14 June 2022

Re: Replacement pipeline between Dungowan Village and Calala - Addendum REF #1

Figure 1.1

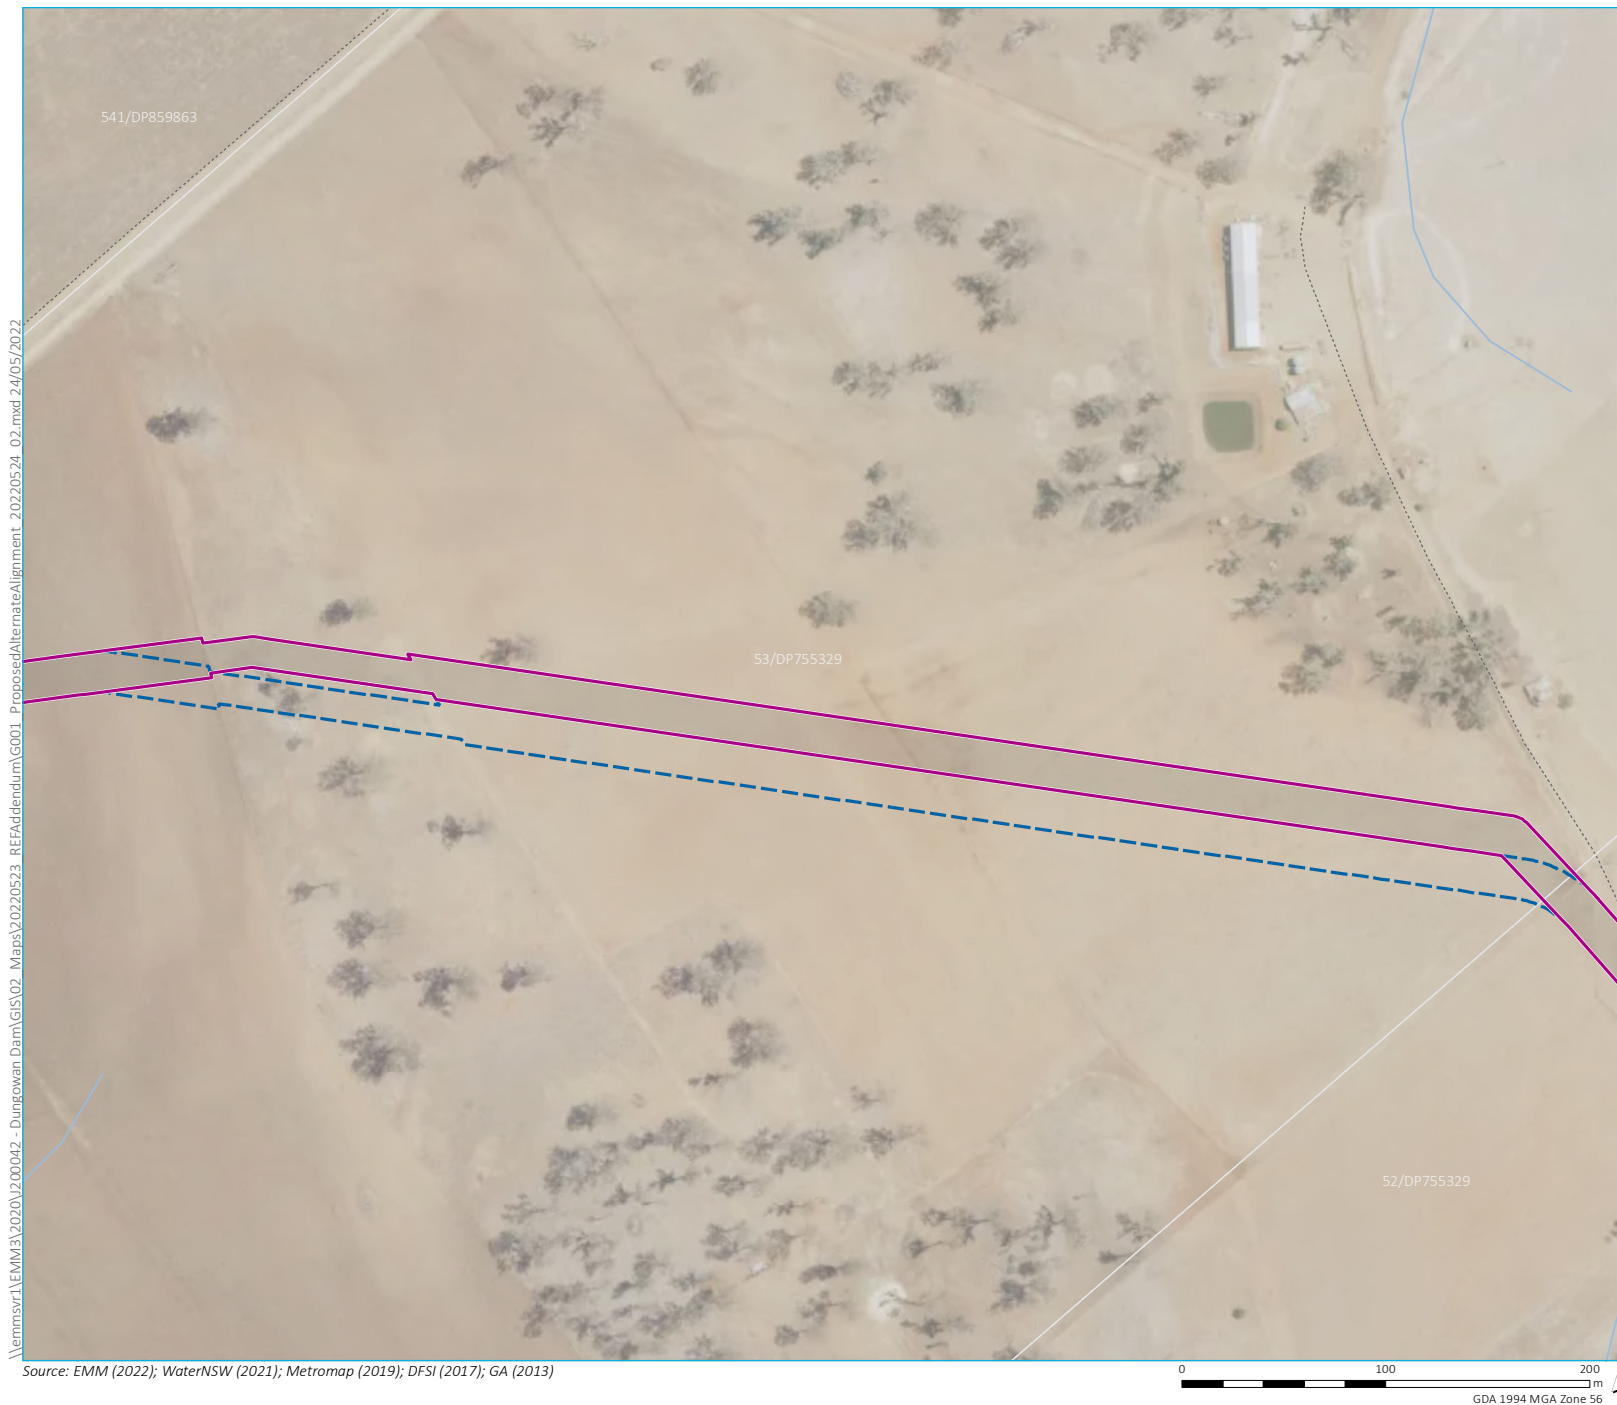
- **Alignment 1** – within Lot 53/DP755329 and as shown in Figure 1.1, the revised alignment of the pipeline involves shifting a section around 725 m in length to the north of the existing alignment by approximately 20 metres (m). The revised alignment will allow for the avoidance of two trees, a rocky outcrop and recently installed irrigation infrastructure.

Figure 1.3

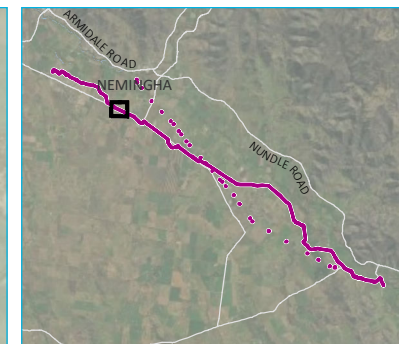
- **Alignment 3** – currently within Lot 3/DP794623 and as shown in Figure 1.3, the revised alignment would shift a section of the pipeline approximately 630 m in length from the north to the south side of Calala Lane into Lot 1/DP1137483. There would also be a small increase in disturbance area on the northern side of the road where the pipeline crosses Calala Lane. The change is required based on current land use requirements and access.

Figure 1.2

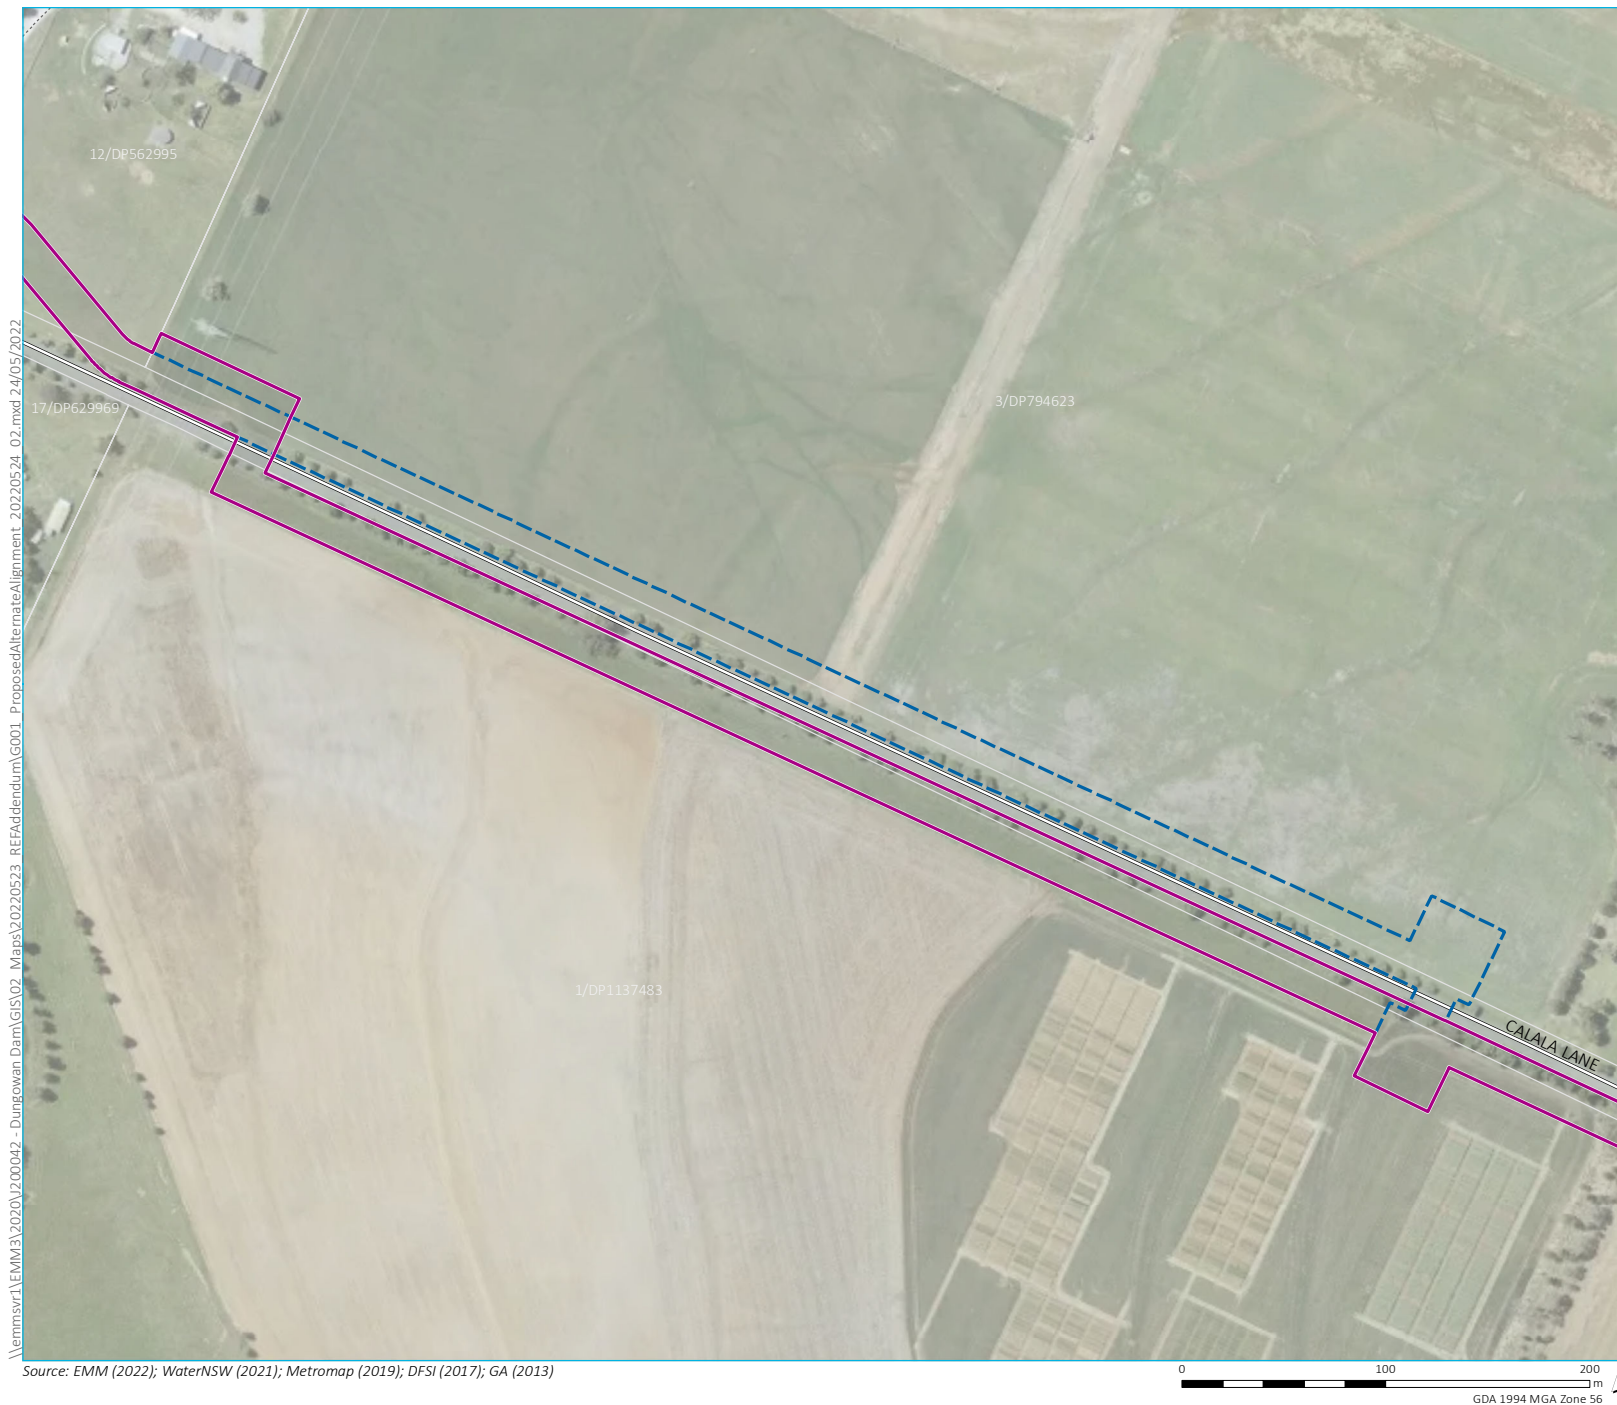
- **Alignment 2** – within Lot 541/DP859863 and as shown in Figure 1.2, the revised alignment involves shifting a pipeline section approximately 280 m in length to the north east of the existing alignment by approximately 10 m. The revised alignment will enable the works to avoid impacts to trees along the southern edge of the alignment.
